SINGULARITY ENTERPRISES

Technical
Service
Bulletin

Professional Audio Service Bulletin

- SUBJECT: Modification of Record Logic
- APPLICABLE TO: All M79 Multi-Track Recorders
- PURPOSE: To allow Record punch-in by pressing only the Record and punch-out by pressing the Play button.

FIGURE 1

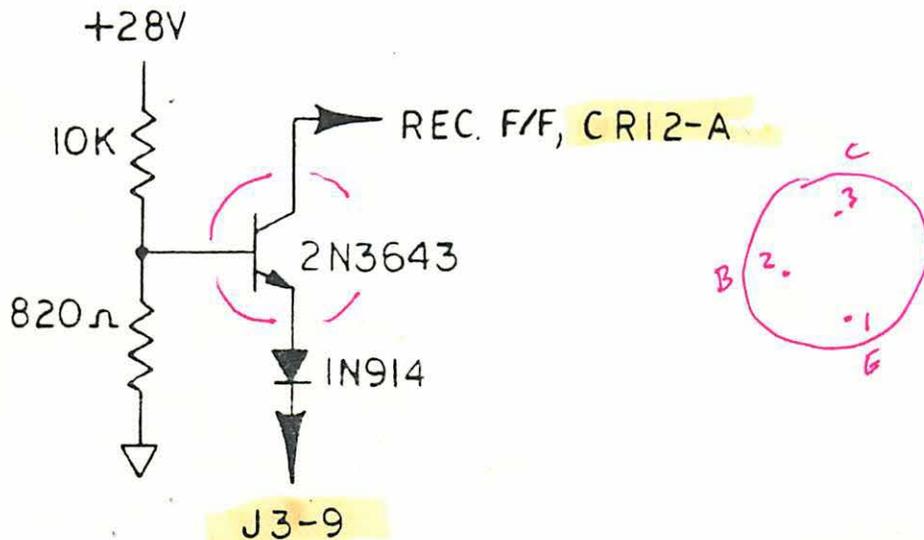
11. Remove Logic and Master Bias Supply board from rear of M79.
12. Add the circuit shown in Figure 1, below, to the Logic board.

- d. Attach perf. board to Logic board, using 3/8 standoff and mounting hardware; ensuring that hardware is isolated from traces by nylon washers.
- e. Connect the 24 AWG wire from the components on the perf. board to Logic Board.
1. Attach wire from 10k resistor to +28v (bottom side of R44).
 2. Attach wire from 820ohm resistor to gnd (top side of R48).
 3. Attach wire from cathode of 1N914 diode to J3-9 (lower left connector).
 4. Attach wire from collector of transistor to anode of CR12, in Record F/F.

FIGURE 2

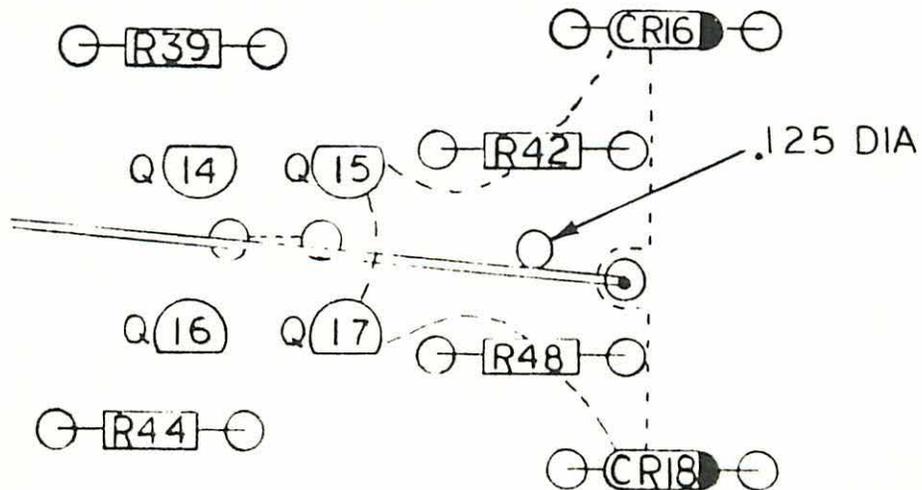
- a. Locate the ground plane between R42 and R48 (lower left quadrant of Logic board), on the rear side of board. See Figure 2, below.
- b. Drill .125 Dia. hole through ground plane, ensuring that hole does not cut any traces on component side of board. See Figure 2, below.

FIGURE 3

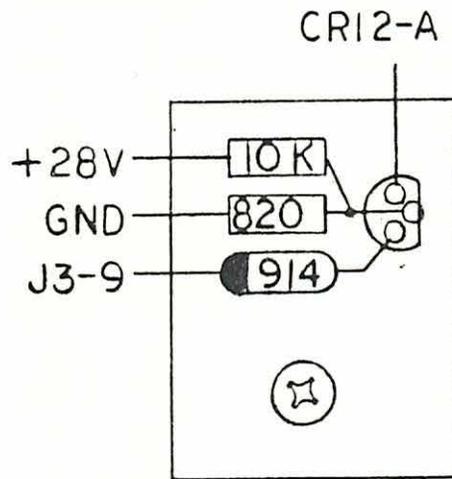
- c. Fabricate circuit shown in Figure 1, above, on 3/4" x 1" perf board, using Figure 3, below, as a guide.

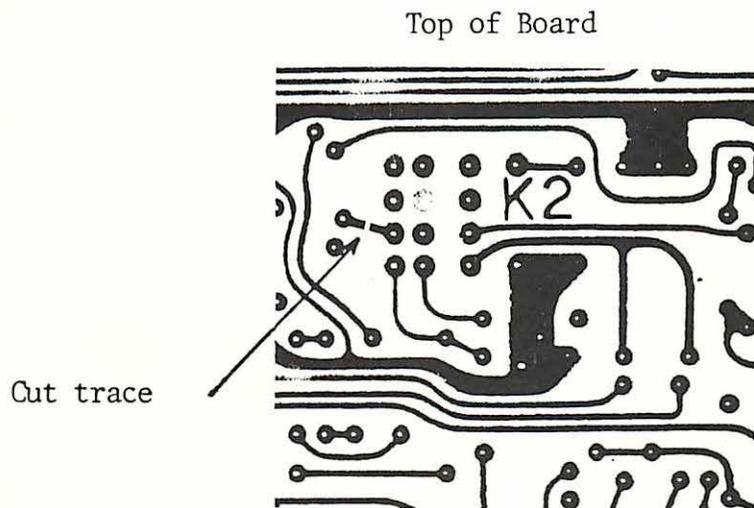
1. Remove power from the M-79.
2. Remove the logic board.
3. Cut the trace from K2-2 to J2-8. See Figure 1, below.

Fig. 4

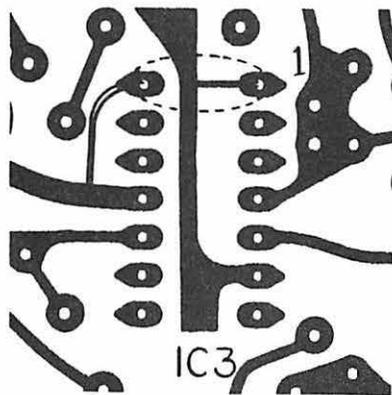
6. Using Mylar sleeving over cap leads; solder .02 μ F cap to traces from IC3 pins 6 and 11. See Figure 4, below.
7. Using Mylar sleeving over cap leads; solder .02 μ F cap to traces from IC4 pins 6 and 11. See Figure 5, below.

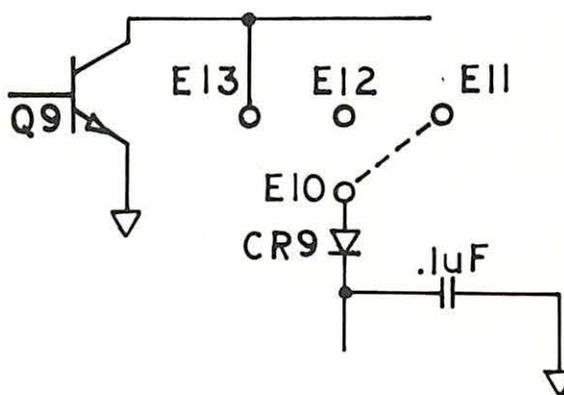
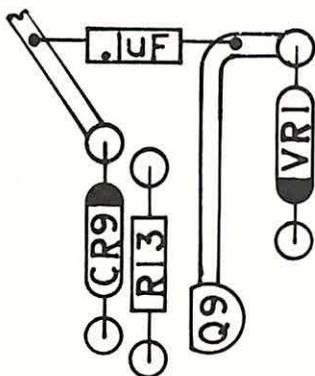
- SUBJECT:** Modification of Record Amplifier Circuit
- APPLICABLE TO:** All M-79 Signal Electronics Boards.
- PURPOSE:** To prevent possible re-recording or "ECHO" phenomenon associated with instruments having high level and fast attack time, such as kick drum, etc.
- REQUIRED PARTS:** 1 Ea. 0.1uF, 50v capacitor 81-2711-5382-7
- PROCEDURE:**
1. Add Capacitor between the cathode of CR9 and the anode of VR1 (ground) as shown in figures below.

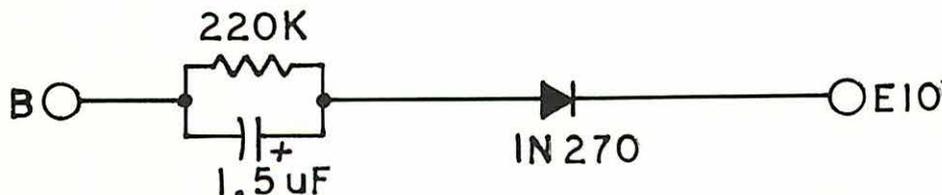
1. Remove R126 from each Signal Electronics Board.
2. Replace C1 on each Signal Electronics Board with the
100pf capacitor.
3. Add the following circuit to the Master Remote Ass'y,
between Pin 'B' and E10.

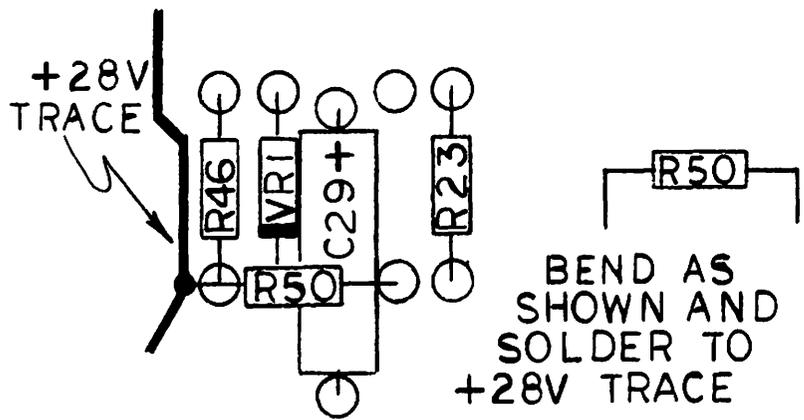
1. Remove R50.
2. Install 20K ohm resistor as shown in figure 1.

FIGURE 1

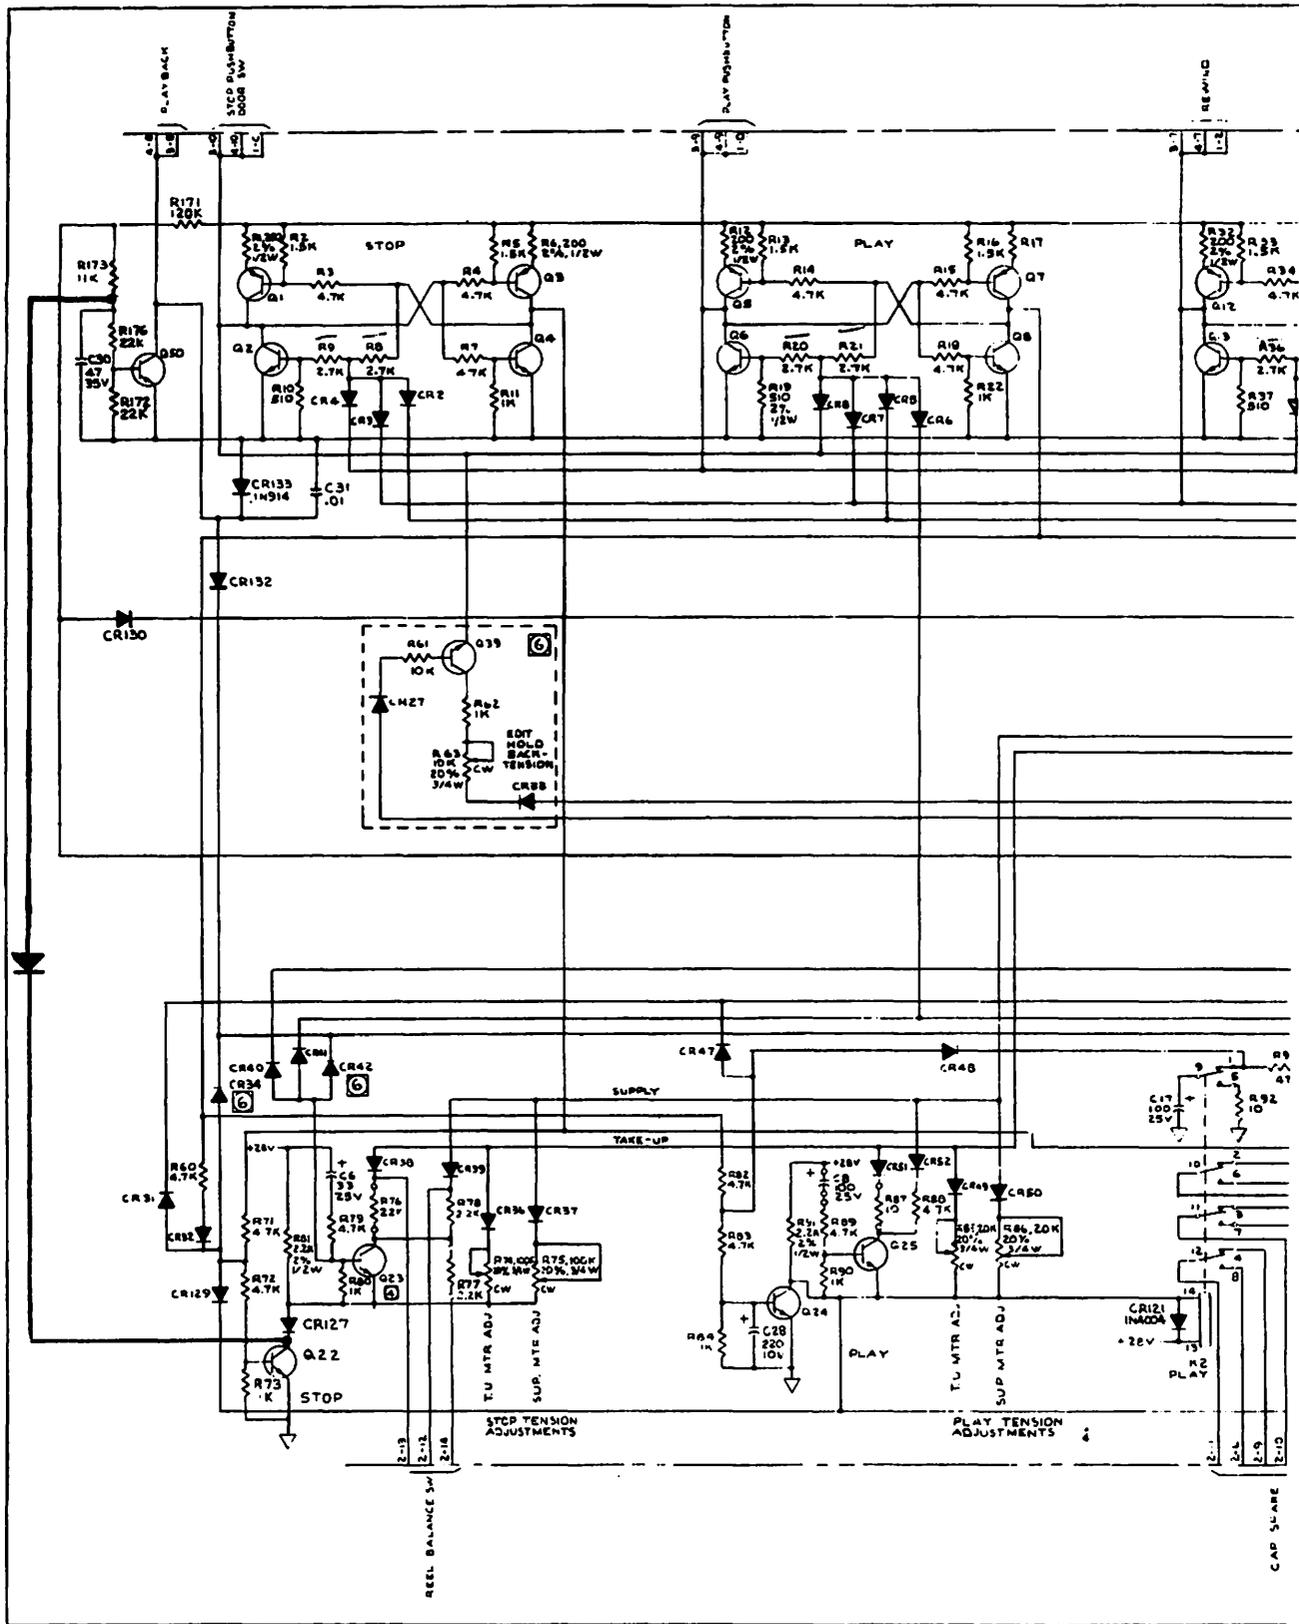
- 1) Remove logic pc Board from recorder.
- 2) Install 1N914 diode from collector of Q-22 to junction of R-173 and R-176. (cathode of diode to collector of Q-22) see Fig. 1. Use tubing on leads of diode.
- 3) Install logic pc board into recorder.
- 4) Thread a roll of tape onto the recorder which has a signal recorded on it and press stop button.
- 5) Manually move tape back and forth. Signal from tape should not be heard nor appear on meters.
- 6) Press mute defeat switch and repeat step five. Signal should be heard and should appear on meters.
- 7) This mod will not effect the monitoring of input signals.

FIGURE 2

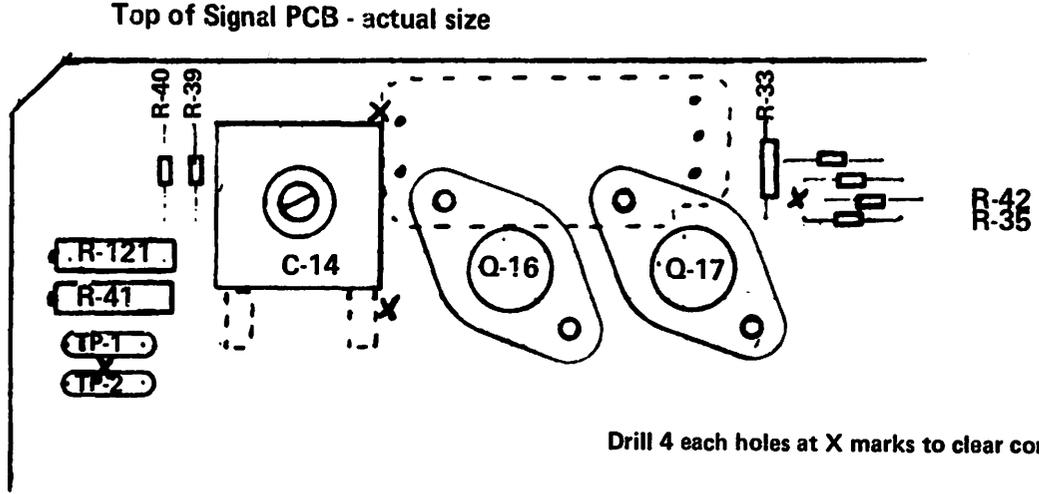
7. Locate same trace as in Step 5 and drill a hole into this trace between C-14 and Q-16 (see figure 1).
8. Mount relay K-A on a piece of perf board and mount the perf board to the mounting screws of Q-16 and Q-17 using two 6-32 nuts (see figures 1 and 2).

New Circuit Configuration

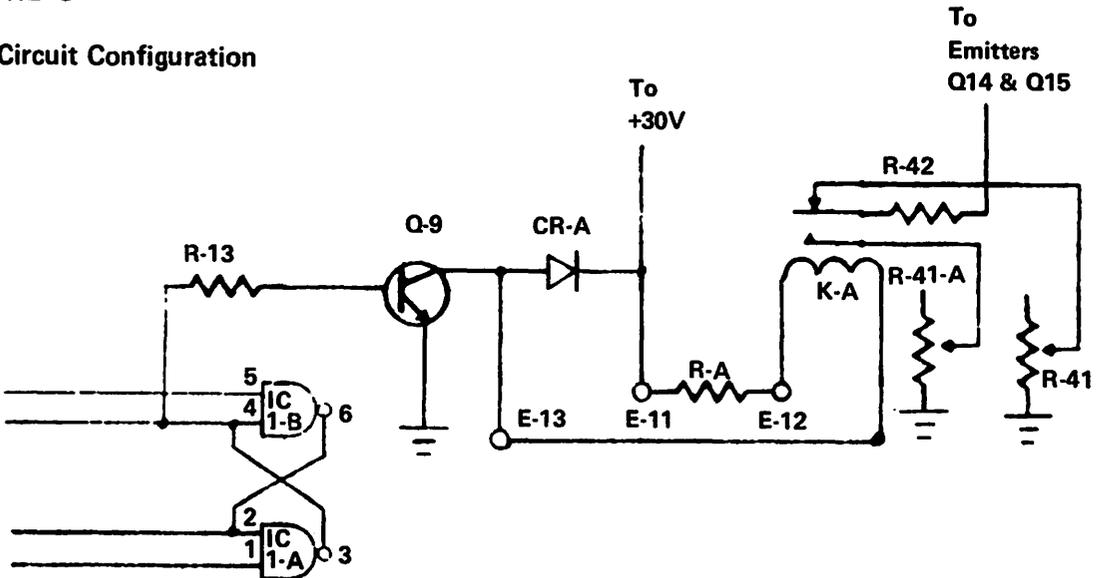
1. Remove Q-20, R-13, R-19, CR-9 and discard.
2. Remove any jumper connected to points E-10 through E-13.
3. Remove TP-2 (white) from board. Use care in not lifting pads from pc board (see figure 1).
4. R-41-A will be mounted in place of TP-2. Clip off rear lead of R-41-A. Drill a hole midway between and slightly above TP-2 mounting holes. This hole and forward most hole will be used to mount R-41-A (see figure 1).
5. Locate trace running from R-42 to wiper of R-41. Cut this trace about an inch from R-42.
6. Drill a hole behind bottom lead of C-14 (erase trimmer). Do not drill through any traces.

Figure 1

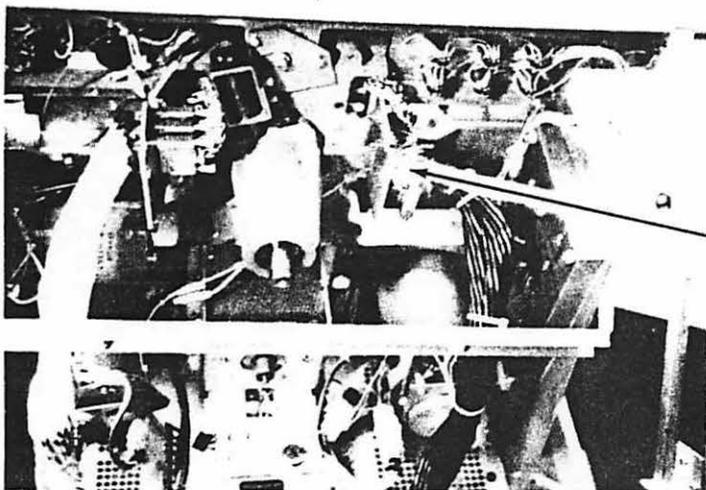
- b. Install new bracket assembly onto transport. (Figure 1)
 - c. Reconnect head connector(s). (Figure 2)
4. Repeat steps 2 and 3 above for bracket on record side.

Figure 3

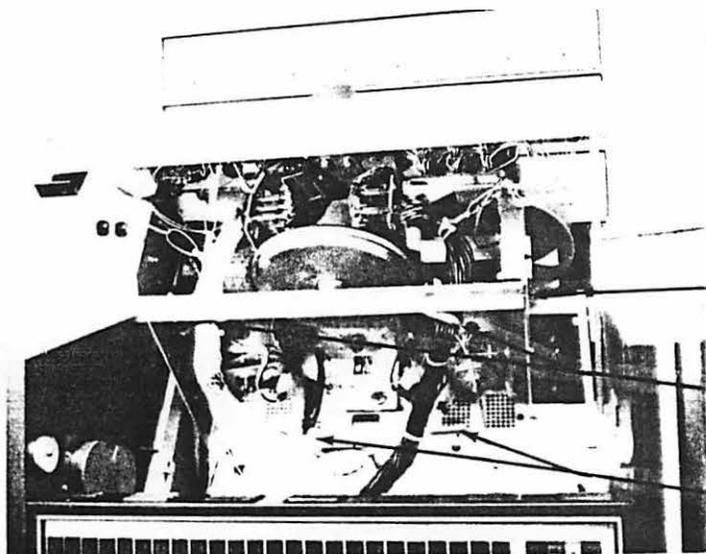
9. Reinstall capstan belt and refer to section 4-30 of the manual for belt tension adjustment.
10. Reinstall lower belt cover.
11. Install head cable mounting bracket 83-3320-2962 as shown (Figure 3). Use existing screw on right side, use 8-32 x 1/2" screw on left side.

12. Attach head cables to bracket using clamps removed in step 1f. Use 10-32 hardware furnished (Figure 3).
13. Install a spring from each head cable bundle to rear of transport wrap around (See Figure 3).

FIGURE 1

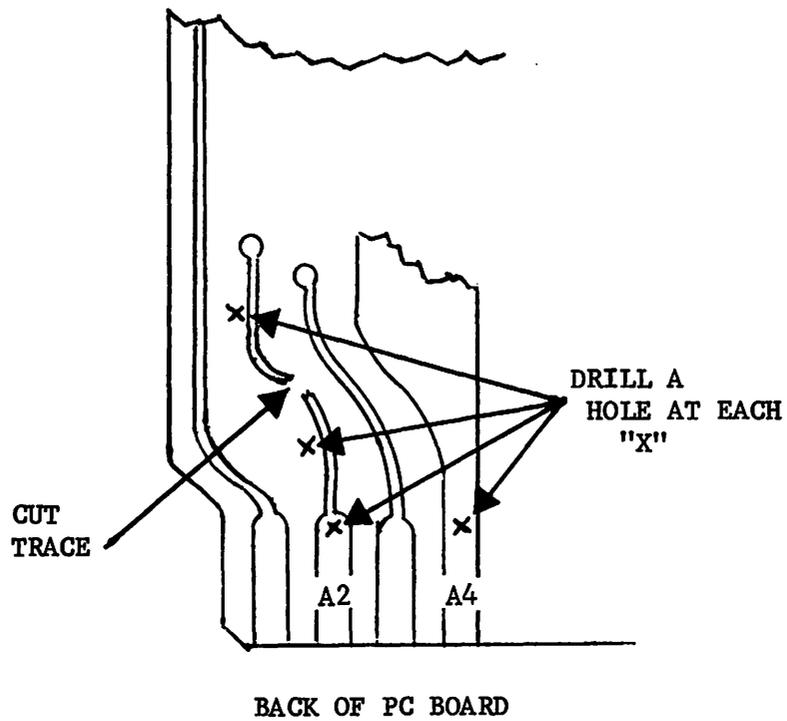
1. Drill four holes .041/.046 inches in diameter at points indicated on figure 1.

2. Cut the printed circuit trace as indicated on figure 1.
3. Install the capacitor, designated C-62 in the holes drilled in the finger contacts (see figure 2). Insure the leads lie flat against the board to prevent shorts to the board brace.
4. Install the resistor, designated R139, as indicated in figure 2. Bend the leads to make contact with the trace on the back of the board and solder. R-139 must be bent as shown to prevent accidental short circuits and to permit the board to be installed in the Recorder.
5. Change Instruction Manual schematics (see figure 3) and parts list to reflect C-62 and R-139.

FIGURE 1

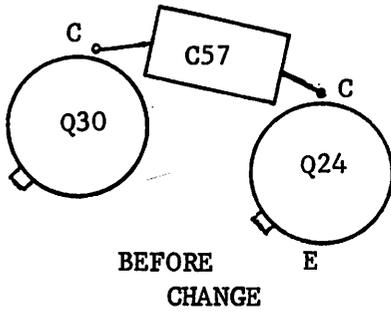
1. Remove Capacitor C-57 which is connected between the collectors of Q-30 and Q-24 (see figure 1).
2. Drill one hole using a .030/.035 inches, drill adjacent to the emitter connection of Q-24 (see figure 2).

FIGURE 3

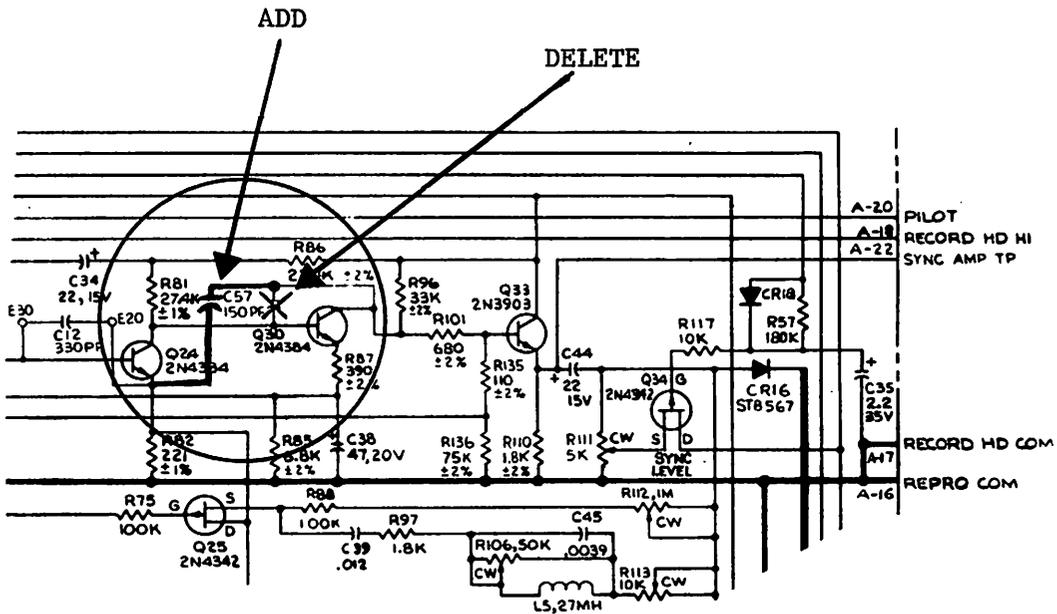
3. Install the new 560pf capacitor, designated C-57, between the collector of Q-30 and the emitter of Q-24 (see figure 2). Insert capacitor lead through new hole, then bend the lead to the emitter trace of Q-24, then solder.
4. Check Recorder alignment and adjust if necessary.
5. Change Instruction Manual schematics and parts list to reflect the new location of C-57 as indicated by figure 3.

FIGURE 1

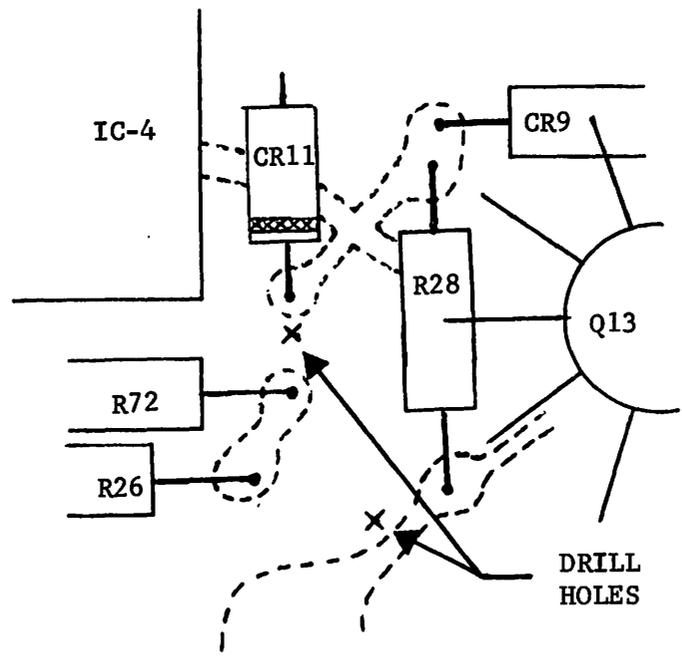
1. Drill two holes .030/.035 inches in diameter at points in figure 1.

2. Install the .001 μ f capacitor (designated C61) by inserting leads through new holes, bend leads to touch adjacent traces, then solder.
3. Check Recorder alignment and adjust if necessary.
4. Change Instruction Manual schematics (see figure 2) and parts list to reflect the new capacitor, C-61.
